**STAFF REPORT TO THE PLANNING COMMISSION**

**SUBJECT:** Leung Property Project Preliminary Development Plan (PDP23-02)

Re: **Engineering review of the Leung Property Preliminary Development plan application for General Plan Amendment.**

# TITLE SHEET

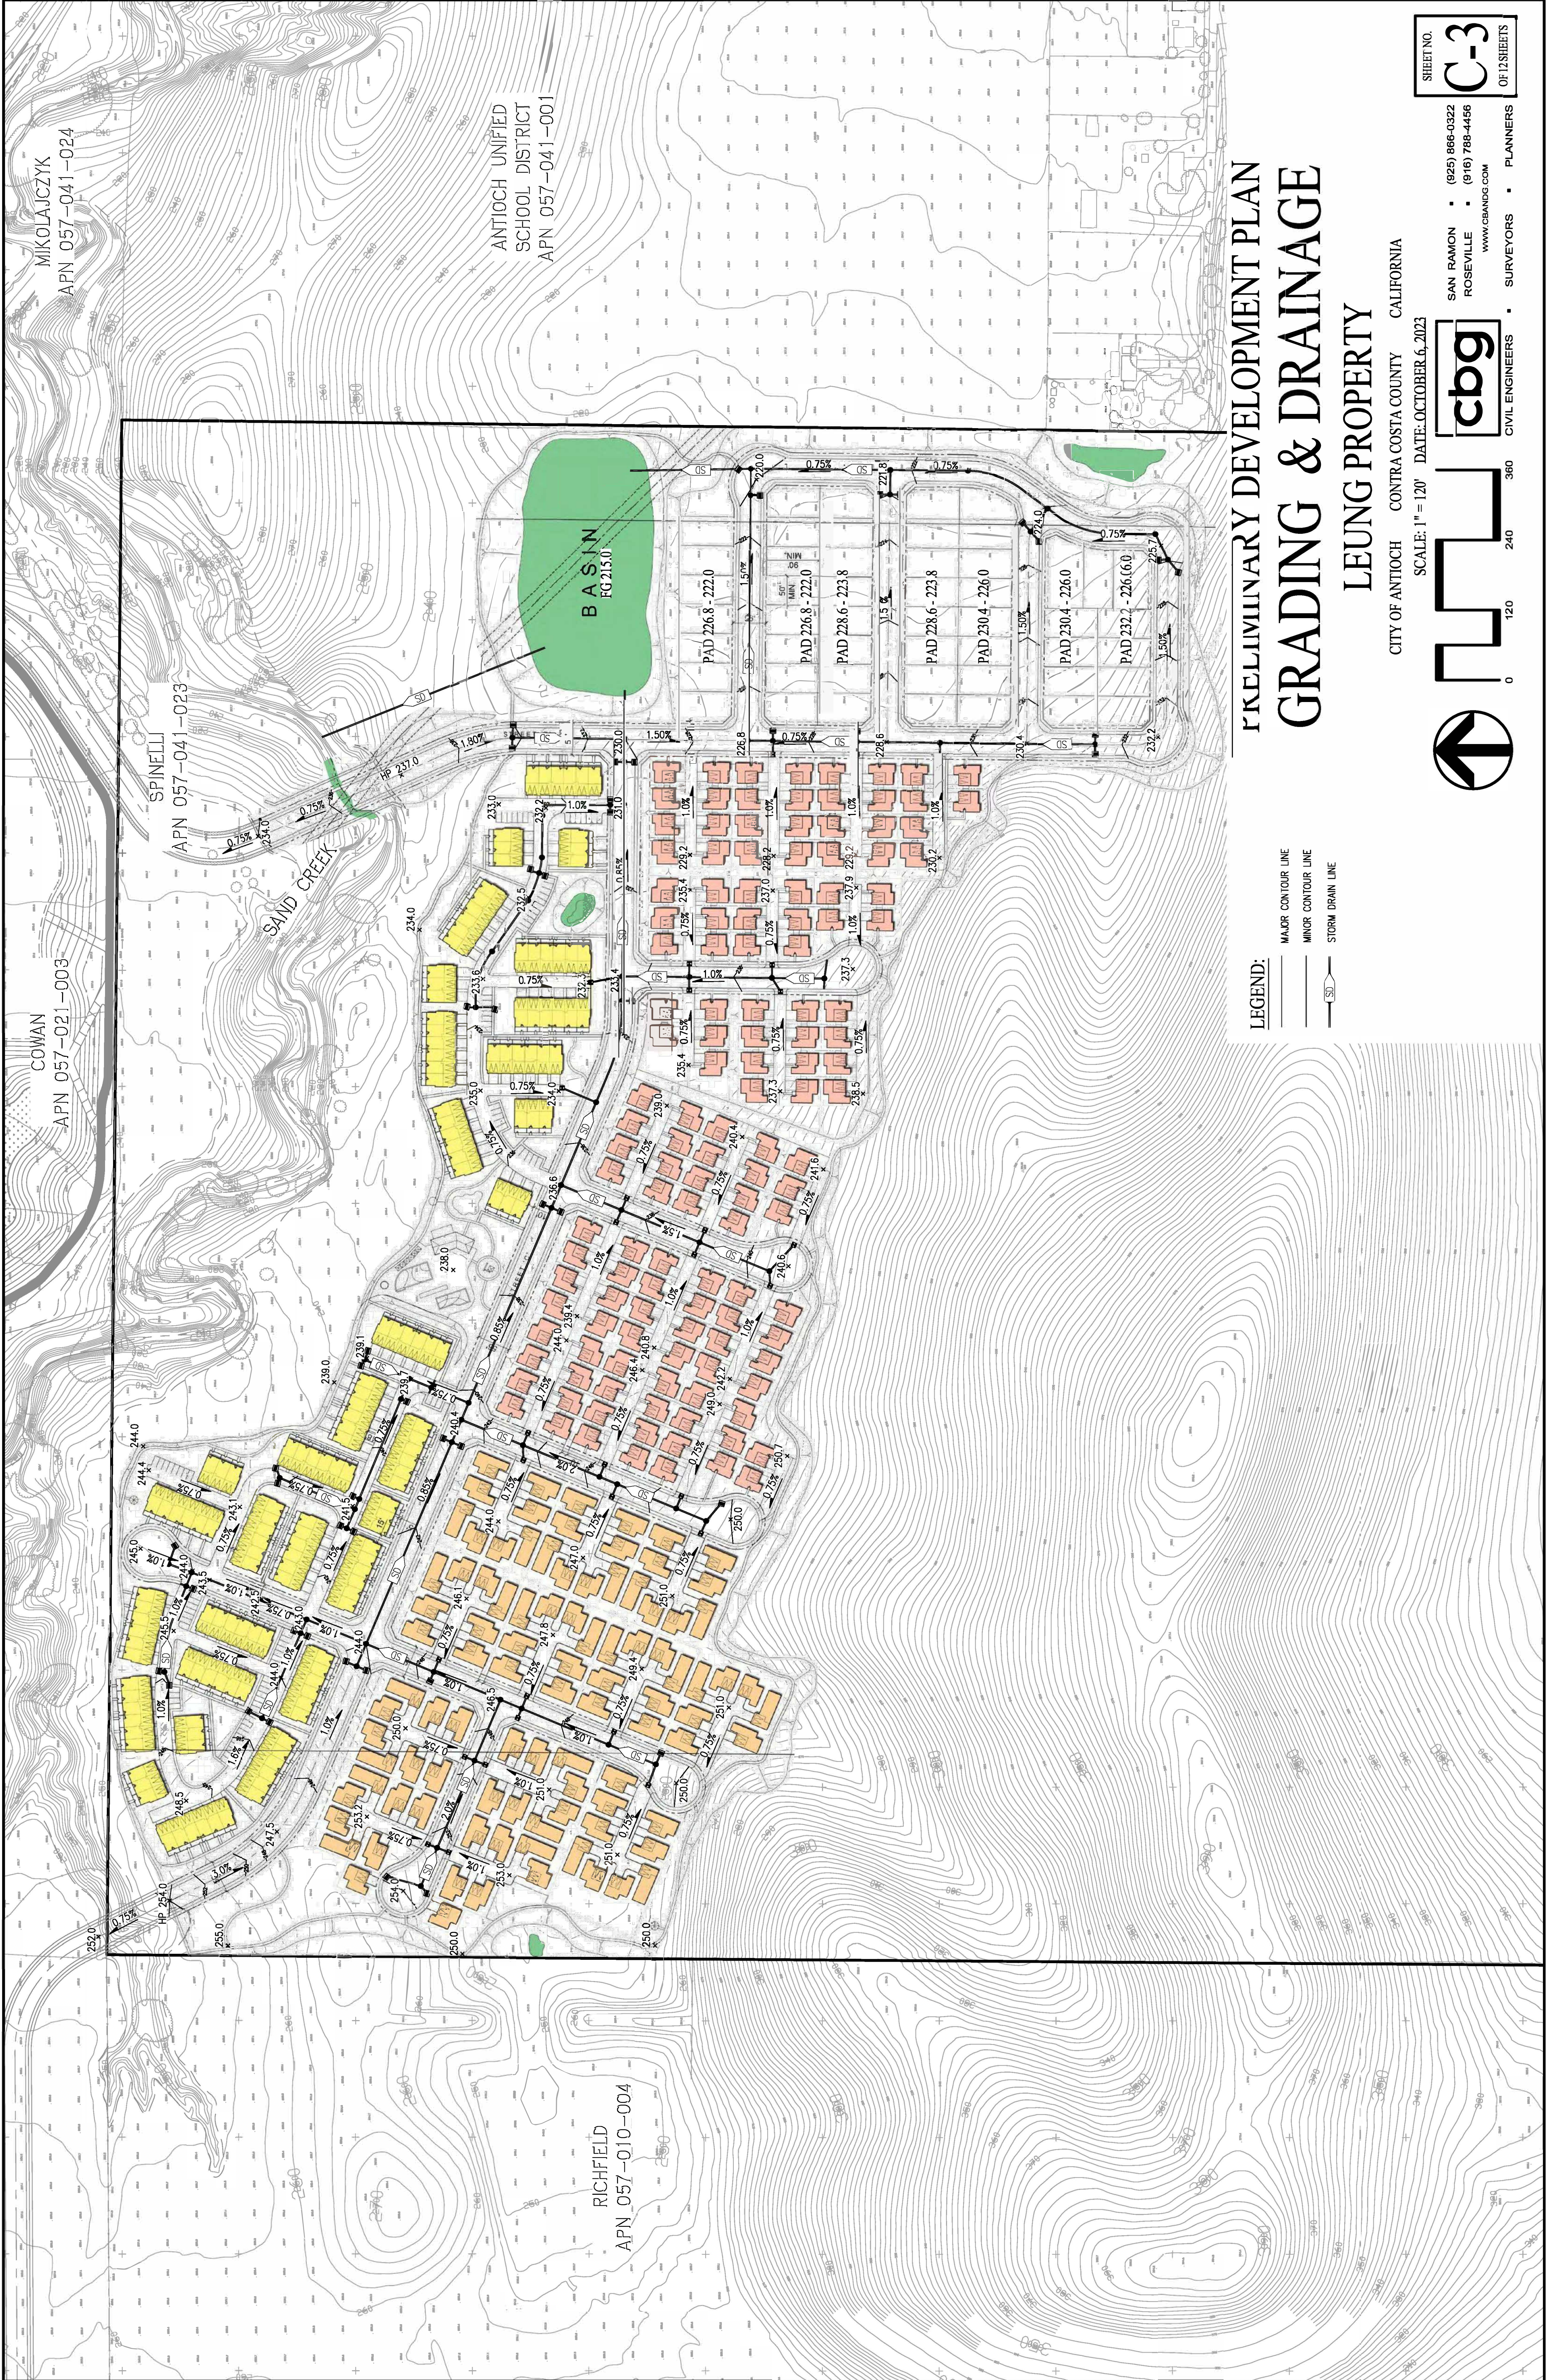
1. **Identify available On Street Parking:** The applicant needs to prepare a very detailed parking plan of each development, showing the number and location of all off-street parking spaces that are available in each residential unit within the project. Every resident should have at least one available off-street parking near their residence. Due to the high number of very narrow driveways and clustered homes, every residential unit should have an available off-street parking stall near their home. If one street parking stall cannot be reached with this plan the plan should be revised with small parking lots designated for visitors, maintenance workers or city emergency vehicles. Sight distance triangles shall be maintained entering every public street and private street and driveway.

2. **Too long of dead-end Cul-de-sac streets.** Per City standard detail ST- 10a and ST-10B the maximum cul-de-sac length is 200 feet. Many of the cul-de-sac streets shown in the development plan exceed this limit and need to be changed to connecting circle streets instead of dead-end cul-de-sacs.

3. **Minimum public street ROW width is 60 feet with 40' wide pavement** (curb to curb) (8+12+12+8) instead of the (6+12+12+6) 56' wide section shown with 36' of pavement.

4. **Maintain good line of sight triangles.** Due to the density of the proposed buildings in the townhome development, the line sight at many intersections with public streets and private streets are being violated. Due to the lack of marked off- street parking, maintaining adequate safe line of line of sight needs to be maintained at all intersections with public streets.

5. **Bike Lanes need to be created in addition street parking on both sides of public collector streets:** The applicant needs to provide room for 6' bike lanes along with parking on both sides of the street for all collector streets.

C4

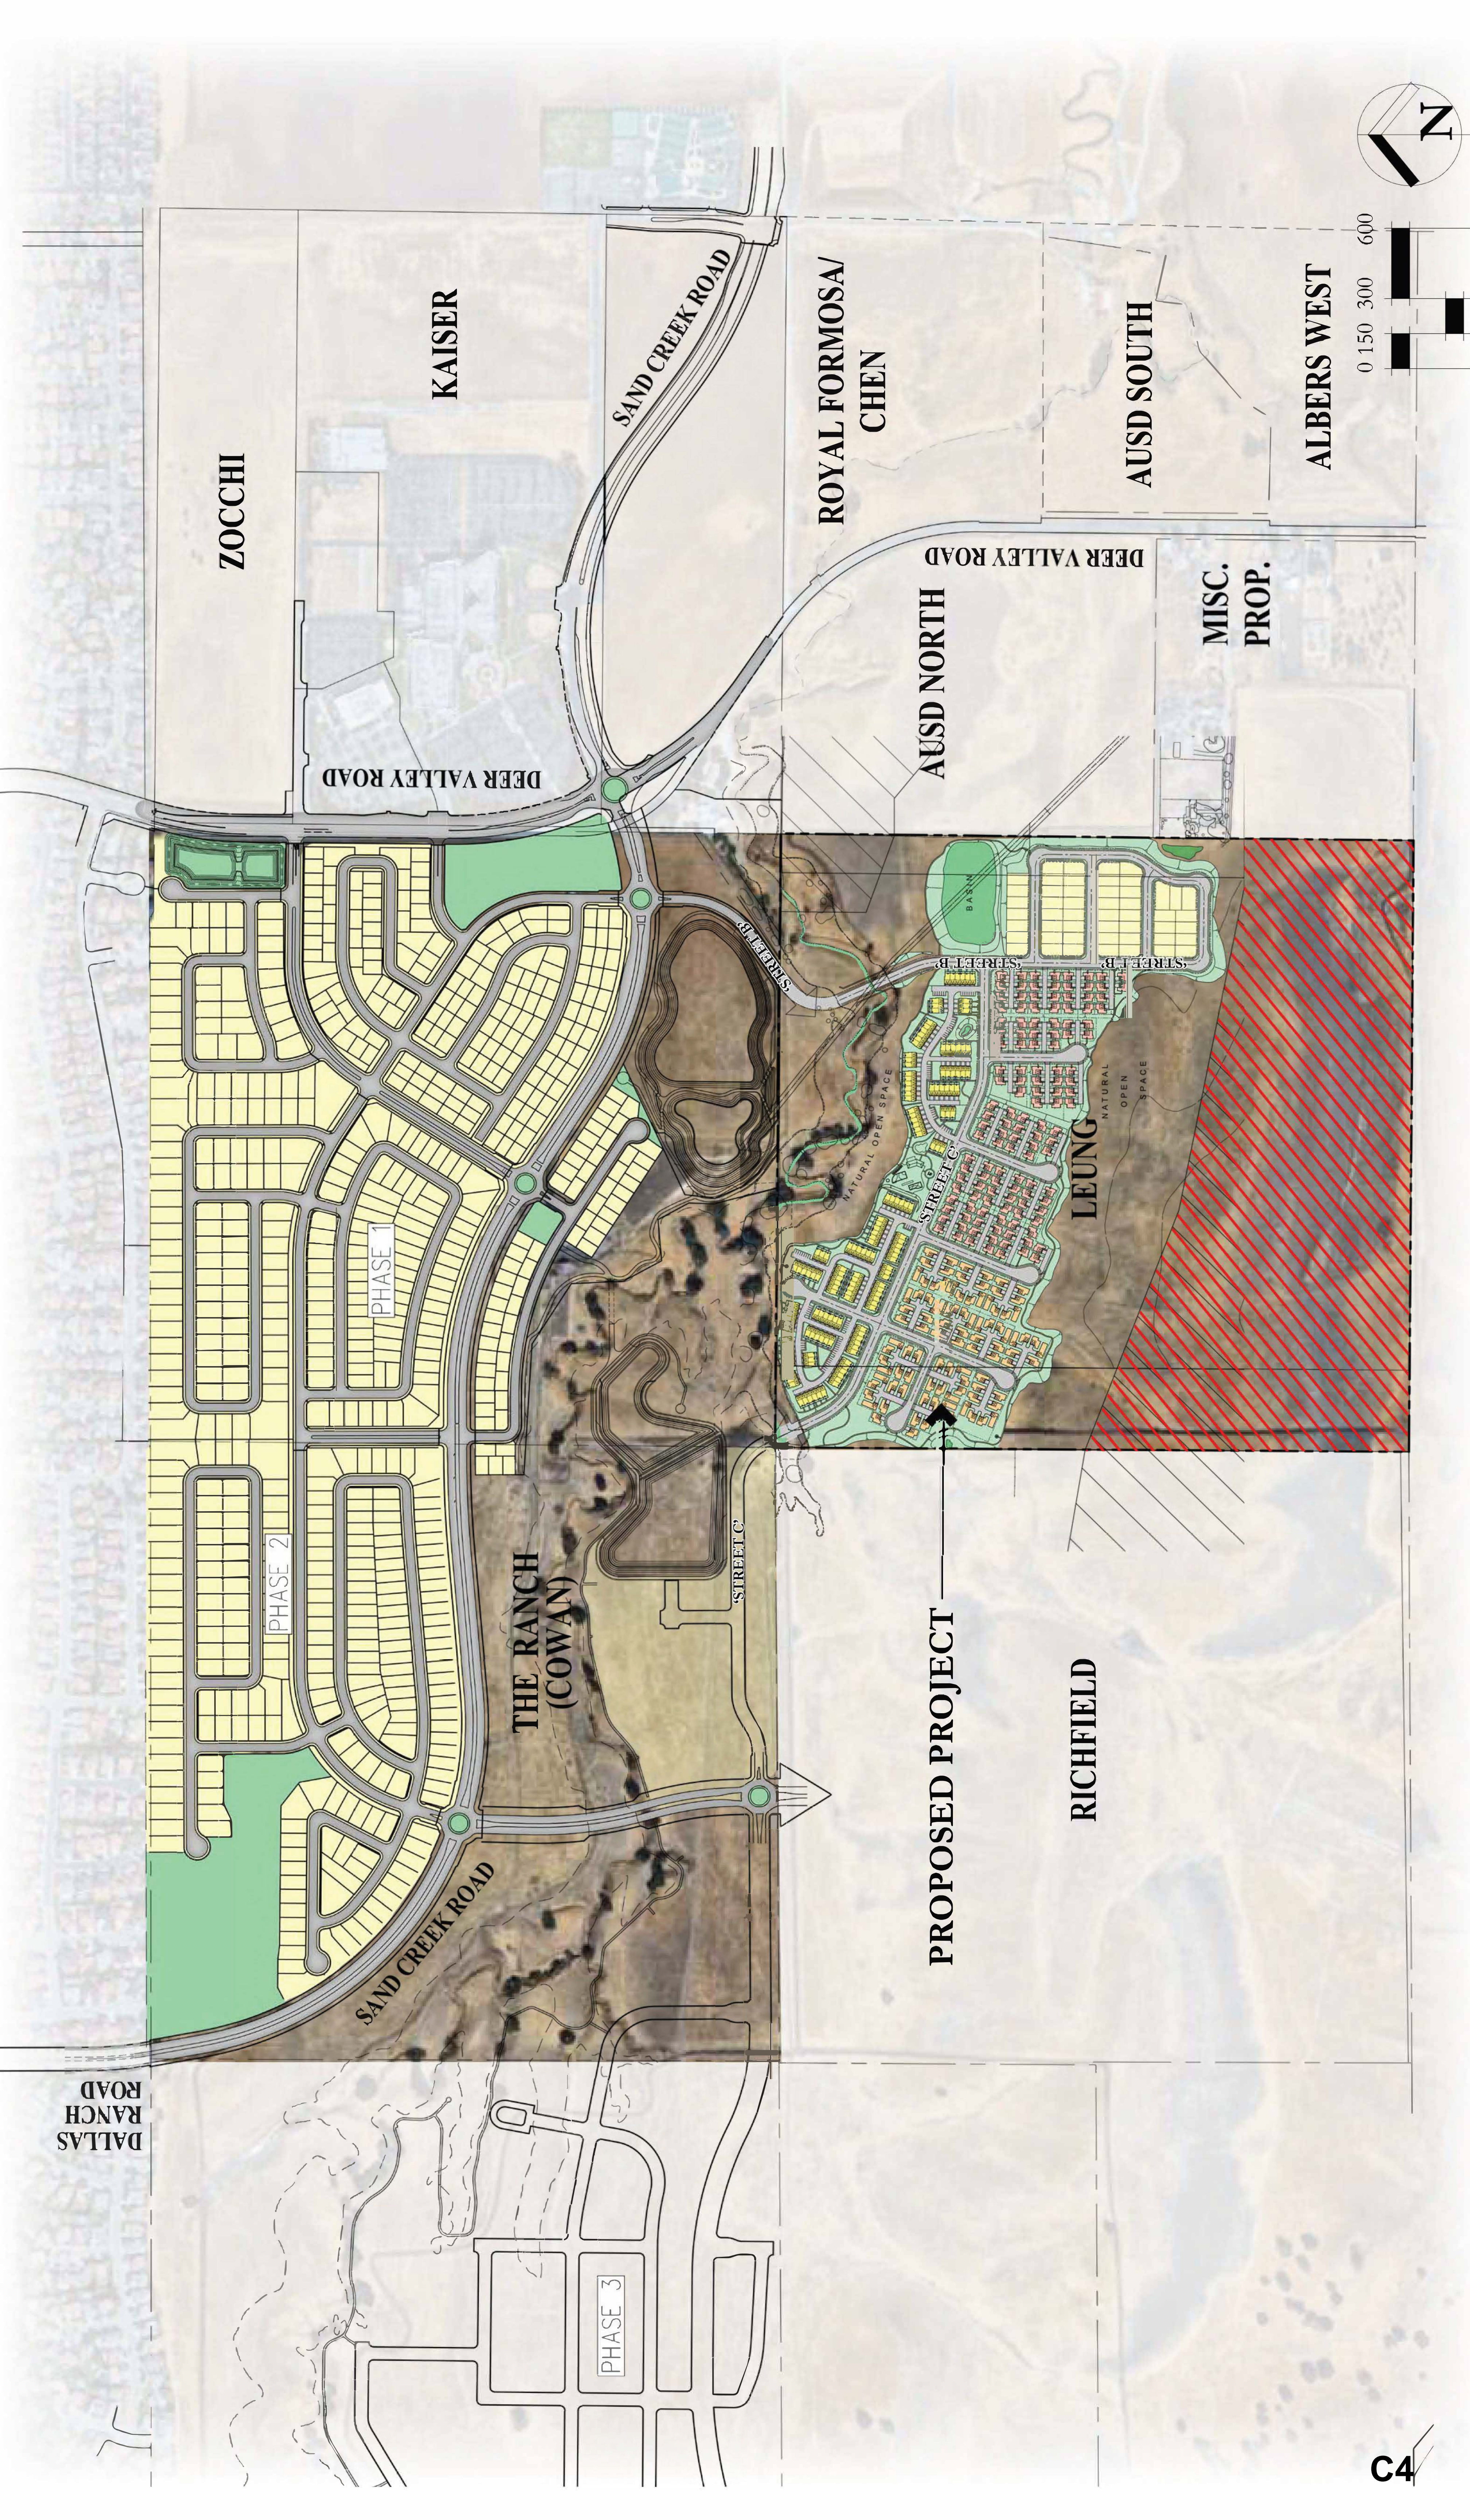
1. A looped water line within phase 4 of the "The Ranch" development need to be shown. The tentative map for this phase 3 of the Ranch needs to be processed at the same time as this project so this project has a street to install the water line and provide a secondary access.
2. Need this subdivision to prepare water model a updated city water master plan.
3. Need the subdivision modeled in the updated city sewer master plan.
4. Need complete ROW of sand creek road dedicated to the city so sewer, water and drainage improvements can be constructed in the proposed Sand Creek Road extension in front of Kaiser Permanente Hospital main entrance.

6. Areas within the various developments should designate future areas for placement of large dry utility boxes throughout the development.
7. Need to show the placement of fire hydrants, streetlights mailboxes within the development due to its effect on parking and adequate line of sight at various intersections of driveways to the public streets.

8. Provide details of the location of all water meters, CATV boxes, PG&E boxes, and other internet boxes on end of all driveways to the public street throughout the development. The developer needs to provide adequate room for the location utility water meters and other utilities to be installed that will meet city residential standards.

9. Street Light standards. Please provide details of a typical streetlight to be used in the project. Please provide the layout of the streetlights and the spacing of street lighting throughout the project. Please indicate on the plan the approximate spacing of the lights and the output from photometrics of the streetlights.
